TOWN OF MILFORD, NH
OFFICE OF COMMUNITY DEVELOPMENT

Date: October 11, 2022
To: Planning Board
From: Camille Pattison, NRPC Assistant Director
Subject: SP2022-08 Sooner Transportation LLC, for the property located at Tax Map 12, Lot 11, 754-756 Elm Street (Horseless Carriage Site). Public Hearing for a Major Site Plan Application to construct a two-story, 10,320 sf. auto sales and repair facility with associated parking, stormwater management/drainage, landscaping, and lighting improvements on the subject property located in the Commercial ‘C’ Zoning District and West Elm Overlay District.

**Re: Sooner Milford Site Plan (Tax Map 12, Lot 11) – 754 and 756 Elm Street
Site Plan Drainage Review**

SOONER MILFORD SITE PLAN

SCALE: AS NOTED APRIL 25, 2022 SHEET 7 OF 12

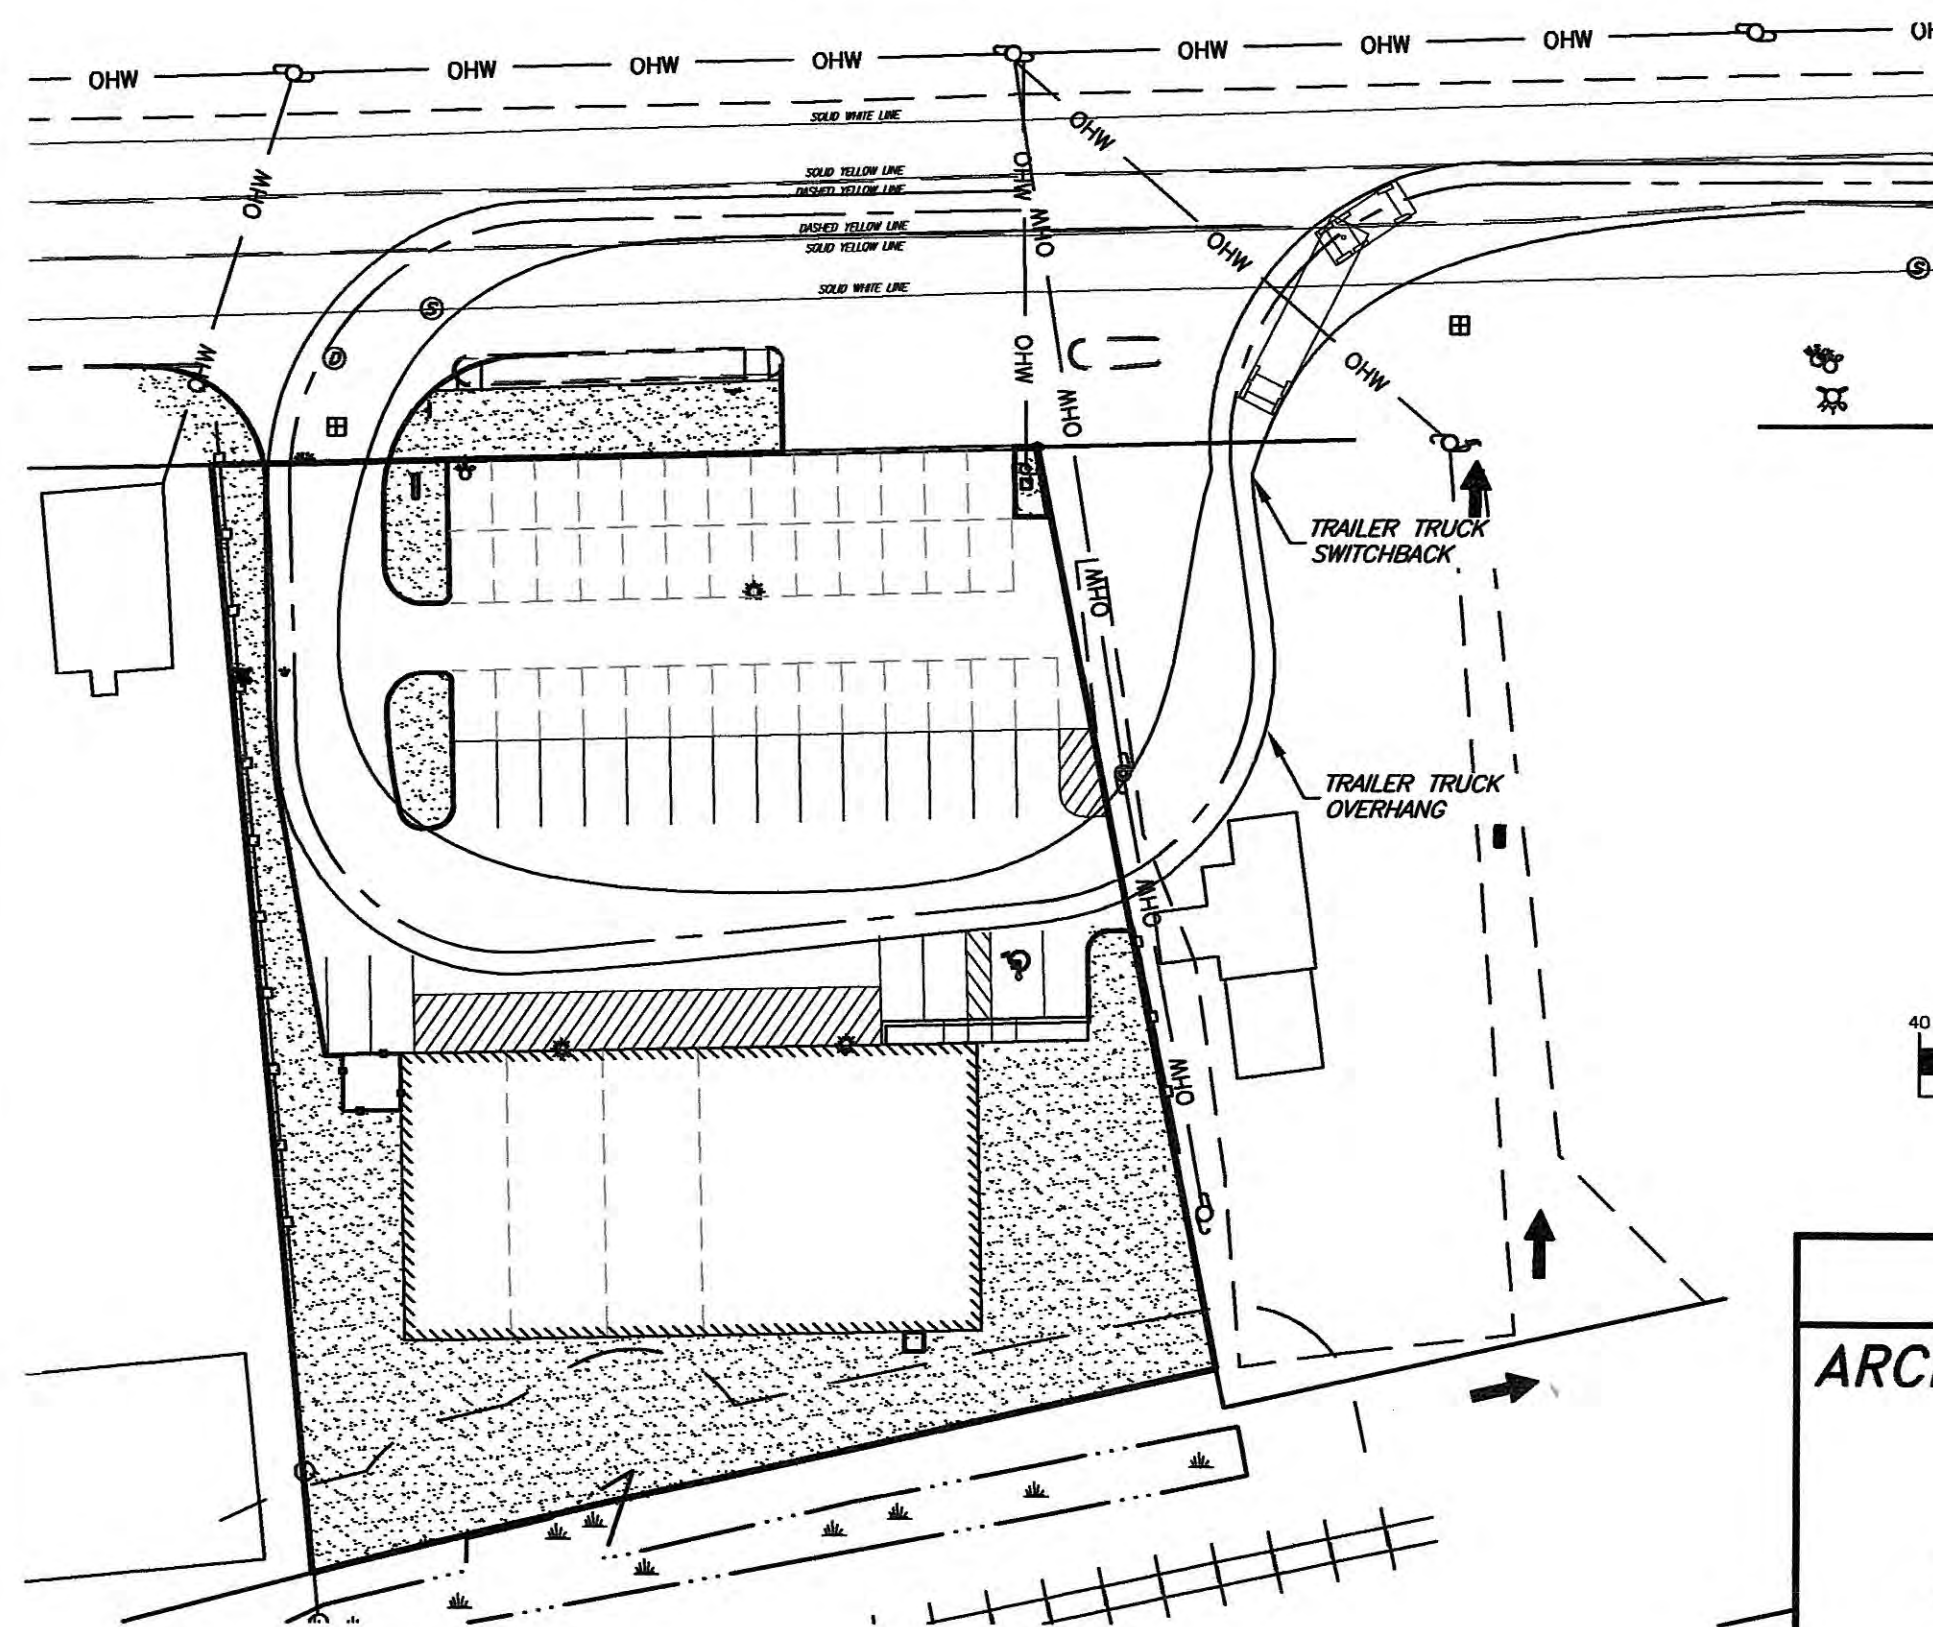
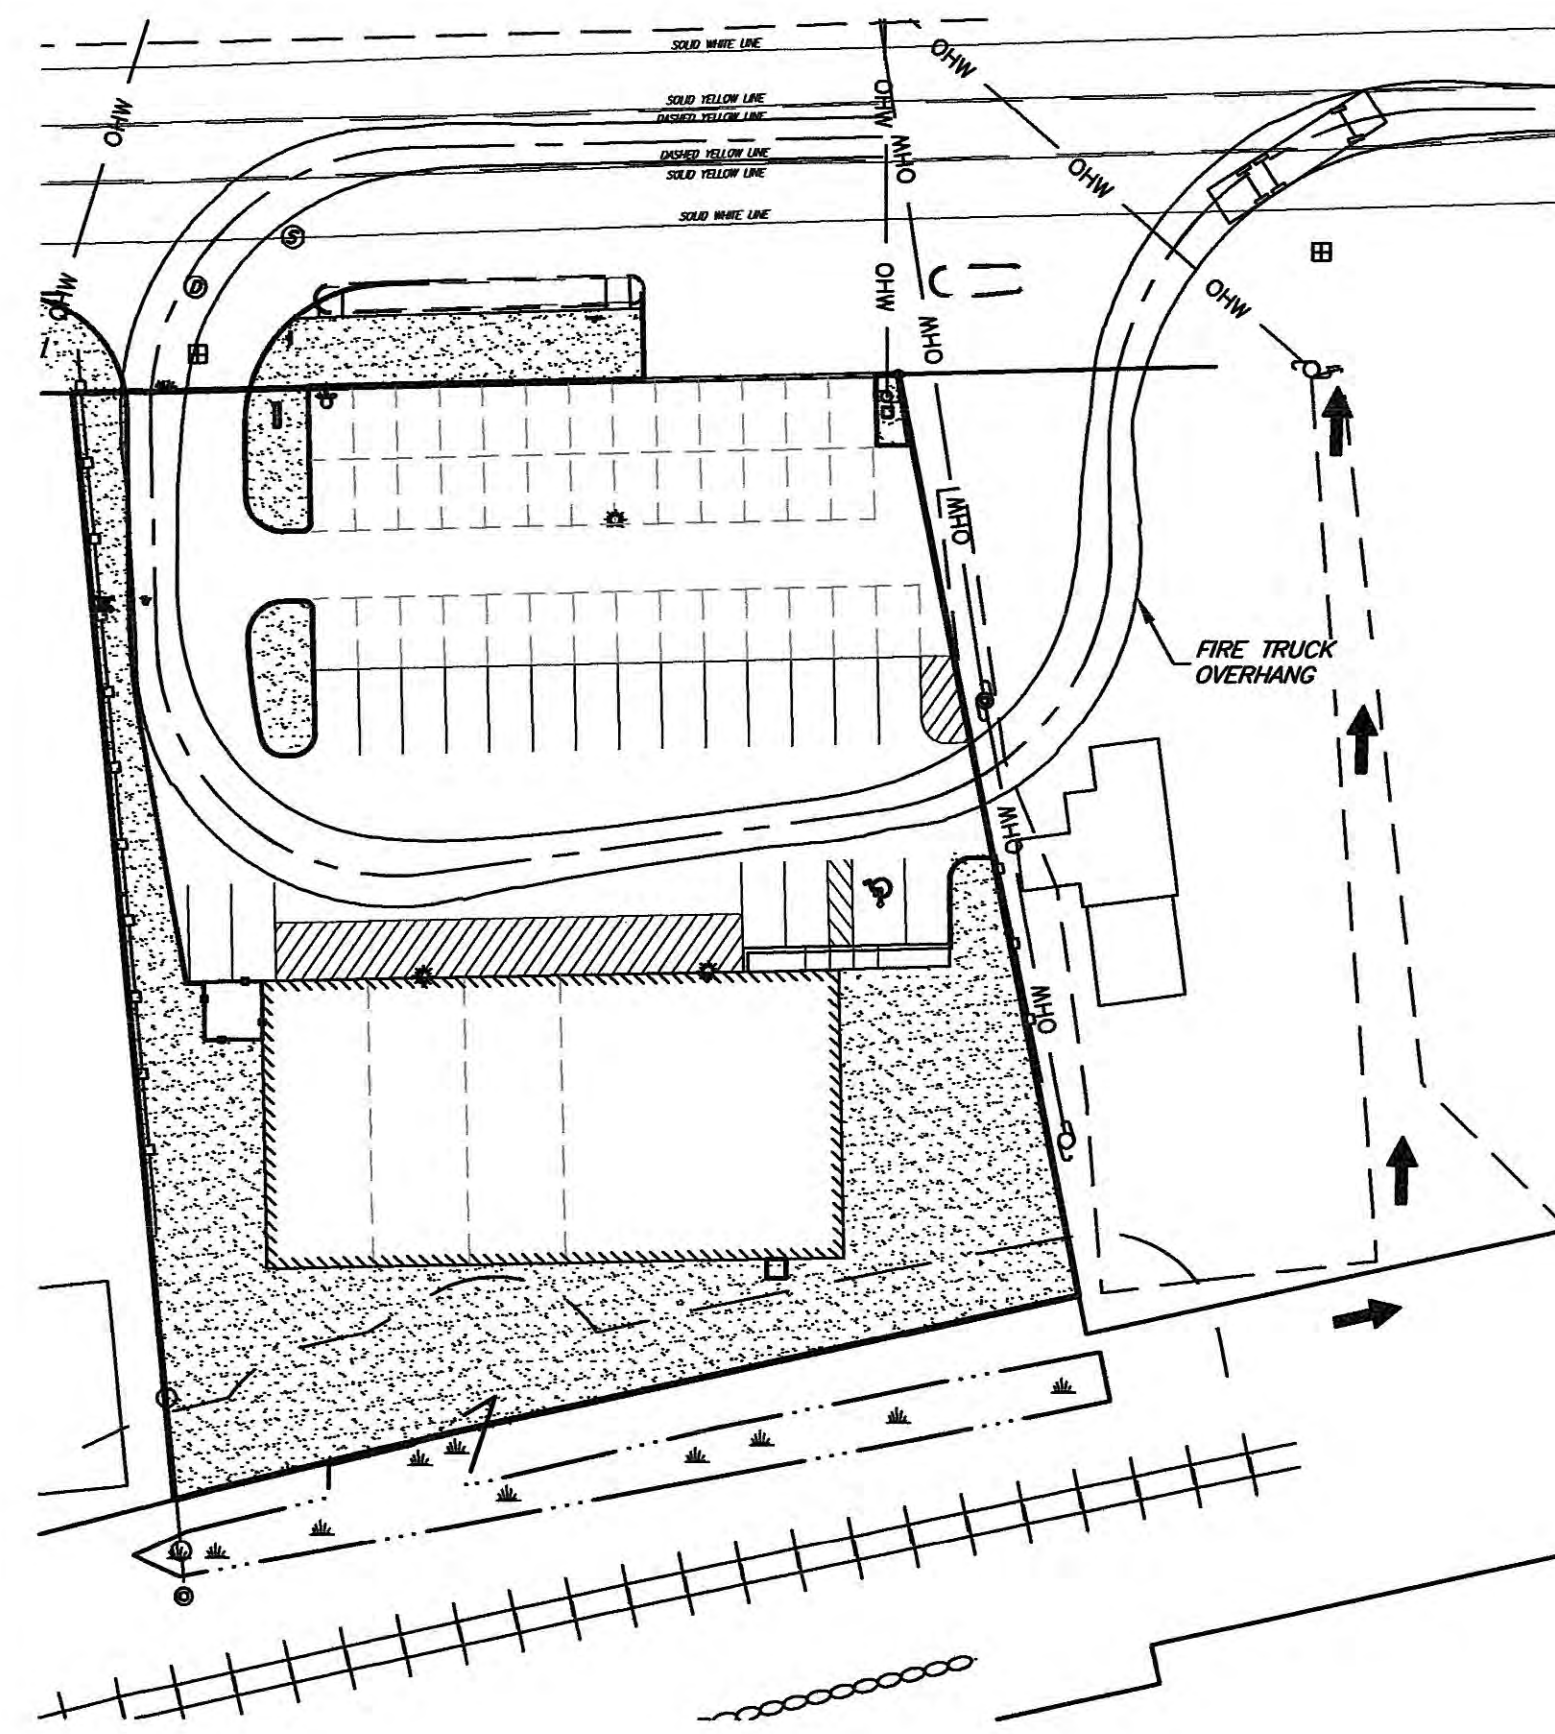
7. The engineer must design the fire department access to accommodate our ladder truck weight, approach/departure angles, and turning radius. Specifications available from MFD upon request. – *Resolved see sheet 7.*

8. Fire lane markings will be required on the fire department access. – *Resolved see sheet 7.*
